Informal document N° 12
(32nd GRSP, 10-13 December 2002
agenda item B.1.1)

OICA PROPOSAL FOR AMENDMENT TO ECE R14

Figure 2

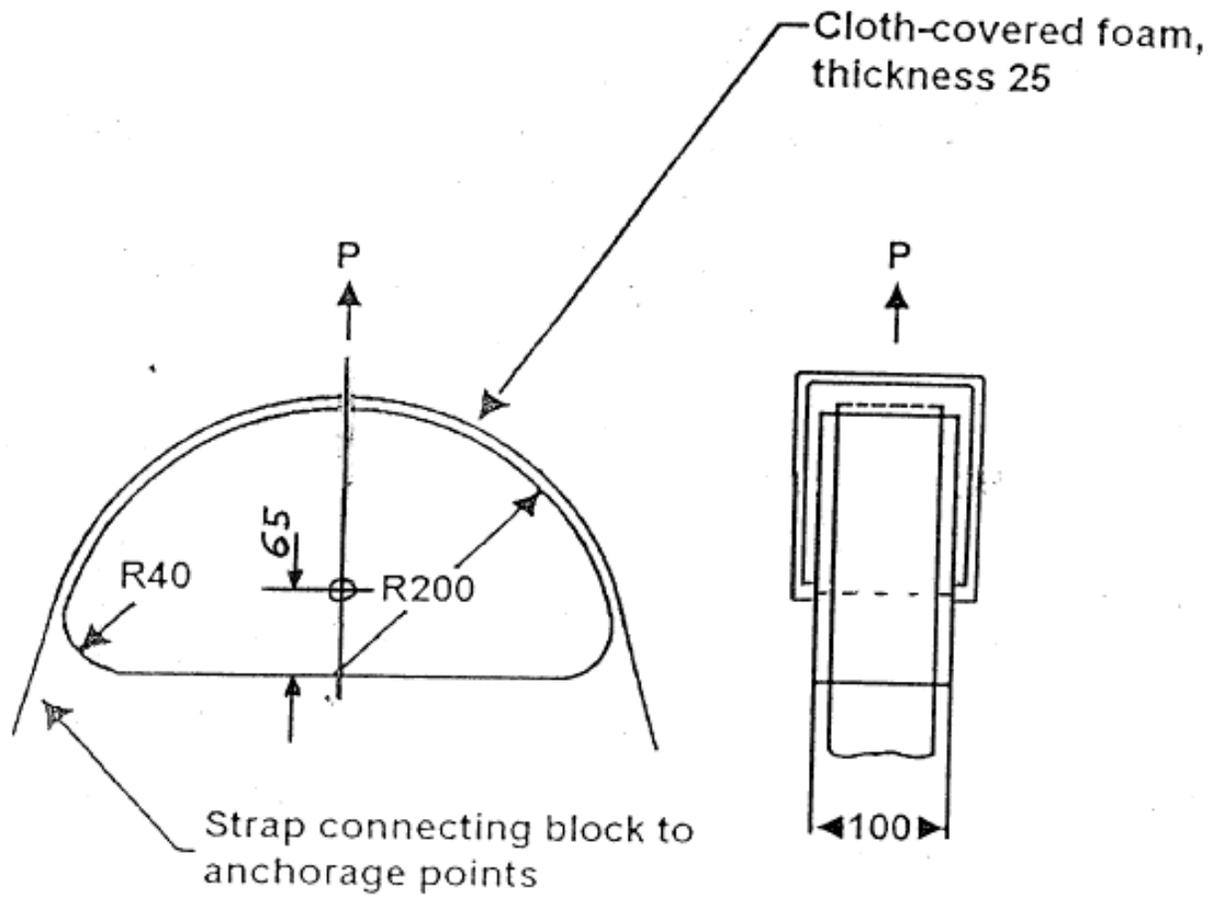
Annex 5, figure 2

Amend to specify the position for applying the force (i.e. 65 mm from the rear face).

Note: The 65 mm dimension proposed for Annex 5 figure 2 was shown in the SAE Handbook

FIGURE 4

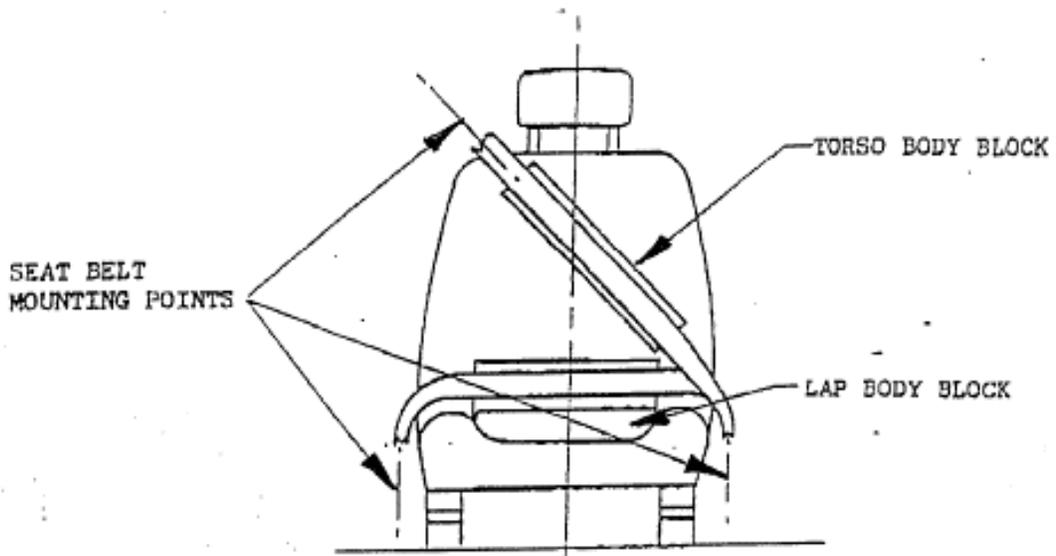
“6.3.4 Traction devices to be used in the tests described in Paragraph 6.4 below are shown in Annex 5. ***The devices shown in Annex 5 figure 1 are placed onto the seat cushion and then pushed back into the seat back while the belt strap is pulled tight around it. The device shown in Annex 5 figure 2 is placed in position, the belt strap is fitted over the device and pulled tight. The arrangement of the devices is shown in Annex 5 figures 4 and 5.***”

Annex 5

Add new figures 4 and 5, to show the arrangement of the traction devices.
